PARTS INFORMATION BULLETIN

GENERAL NO. 273

NEW
BRAKE DESIGN

1959
PASSENGER CARS

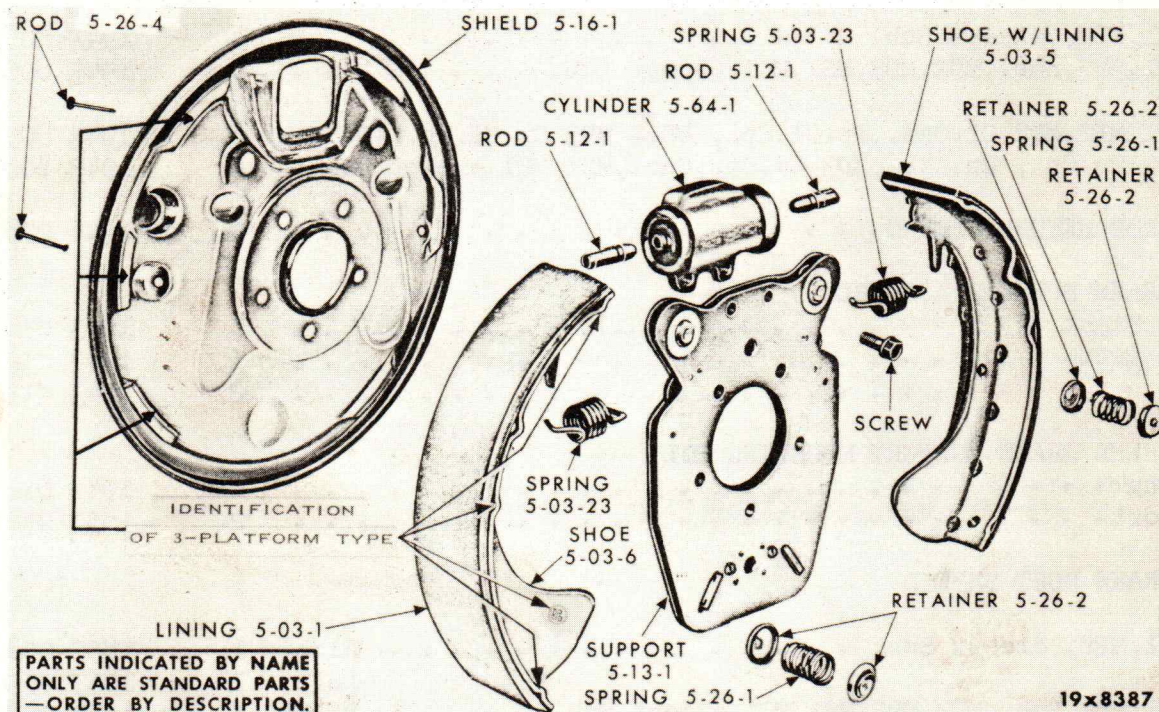
Recently, production began using a new improved brake design which is known as the 3-Platform Brake. The basic feature of the new brake design is that each Shoe will have three (3) loops on each side of the shoe table rim which will ride on three (3) companion platforms, or ledges, pressed into the Brake Dust Shield. This change affords better shoe control and more accurate adjustment. Since shoe tolerances are critical, only Chrysler MoPar approved Shoes should be used for service replacement. MoPar Shoes are now easily identified by the Chrysler trademark **PD** stamped on the Shoe web.
